## MEMO

**RE:** Aggregate Industries – WCR, Inc., DRMS Permit No. M-2004-031, Hazeltine Mine  
Enforcement Hearing

Consideration of a possible violation, corrective actions, and civil penalties, for failure to minimize disturbance to the prevailing hydrologic balance in the surrounding area and failure to protect areas outside the affected land from damage.

# Groundwater elevation in wells near Orr Property

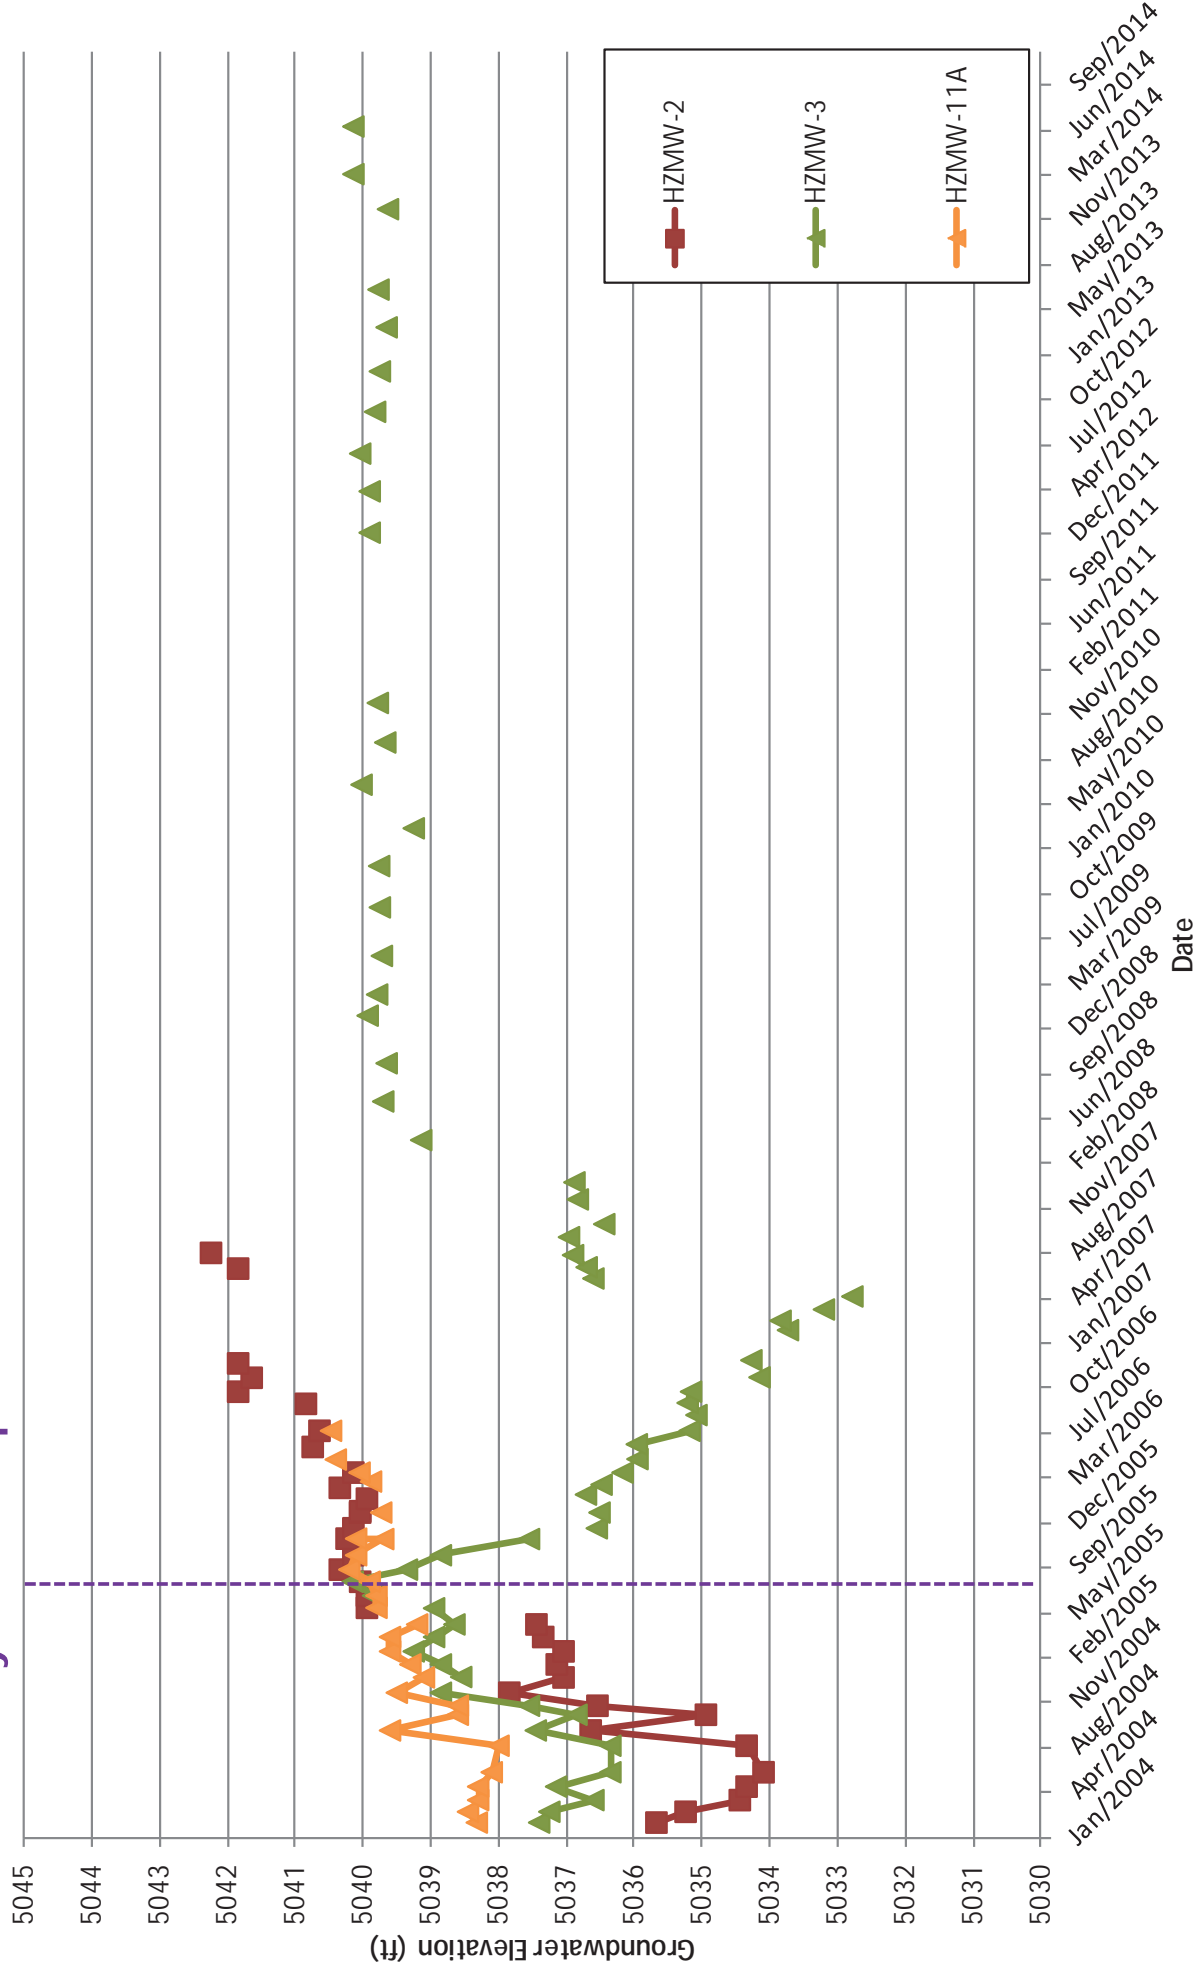
Slurry wall completed

# Groundwater elevation in wells east of the Hazeltime Mine

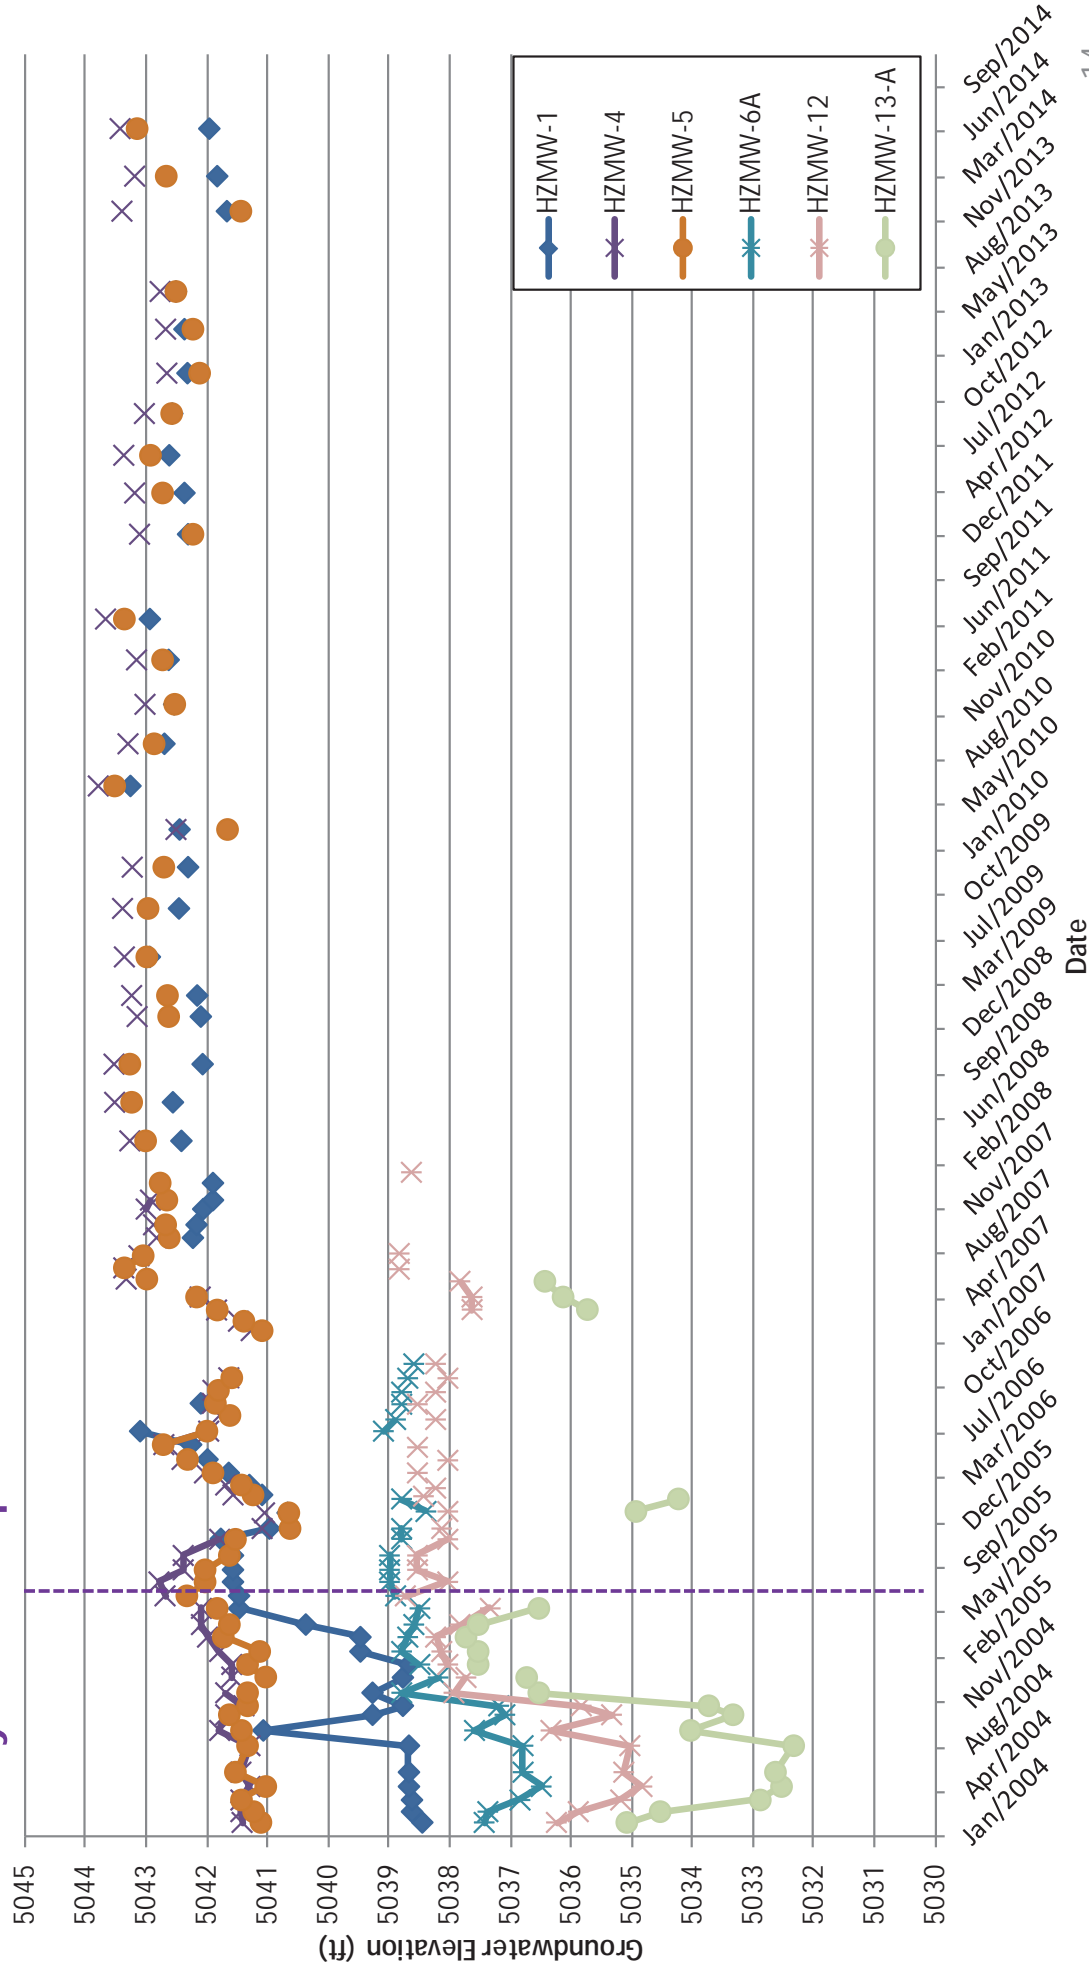
Slurry wall completed

# Groundwater mounding at the Hazeltime Mine

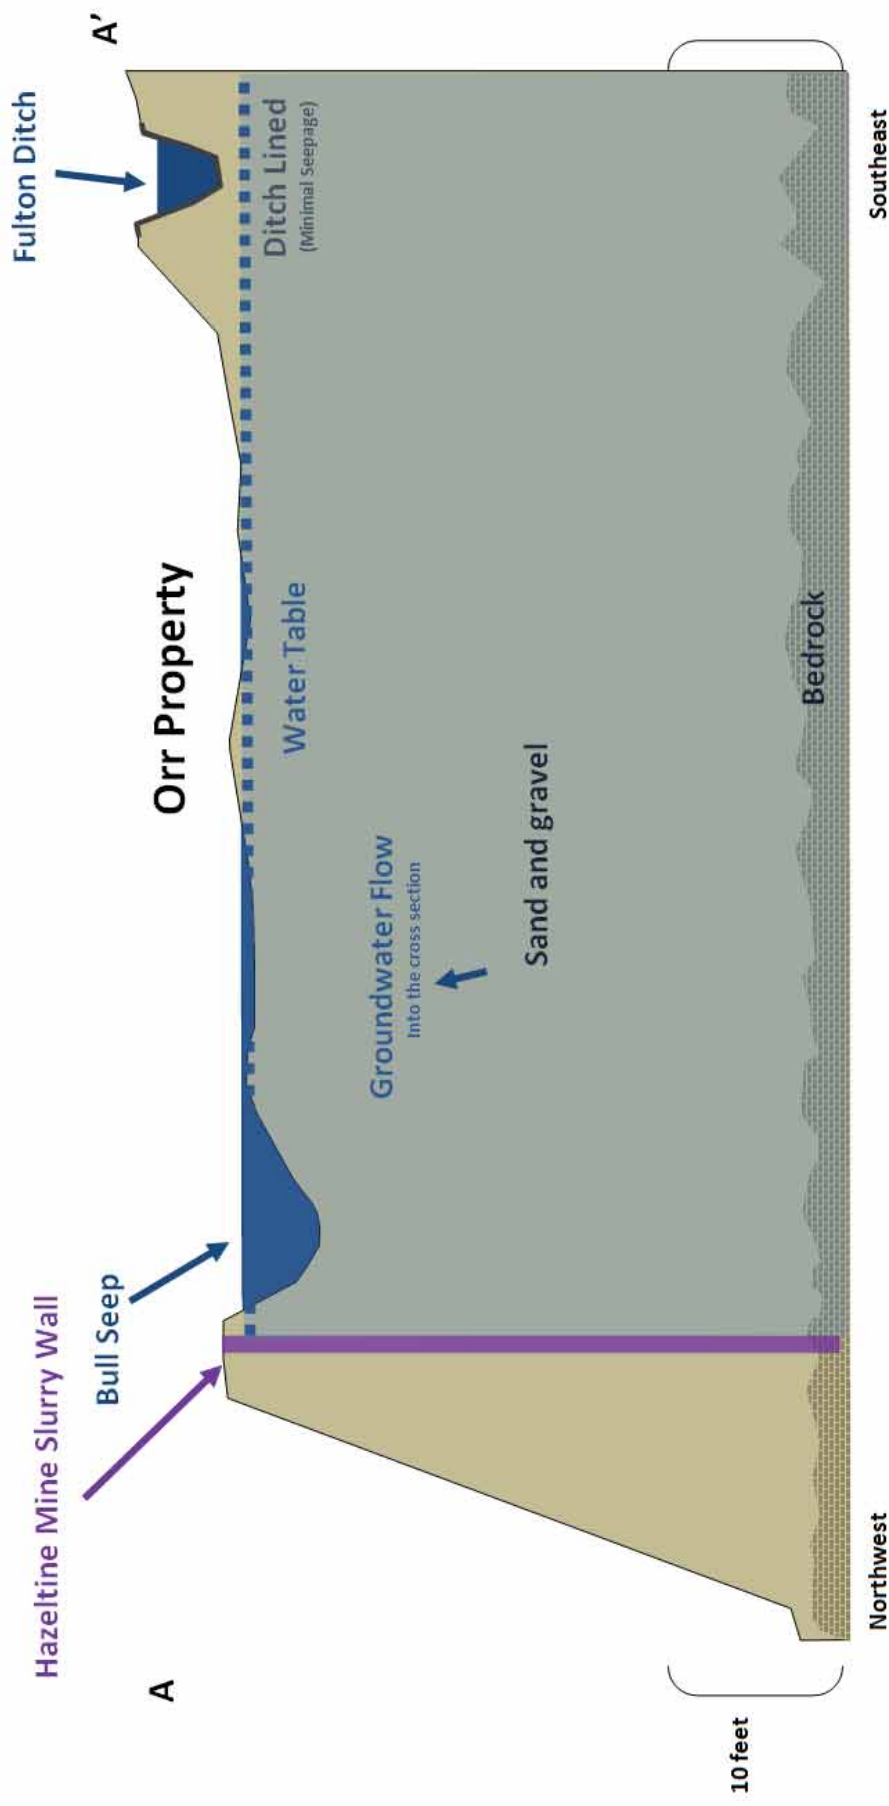
Result: Groundwater table above the land surface throughout most of the Orr property.
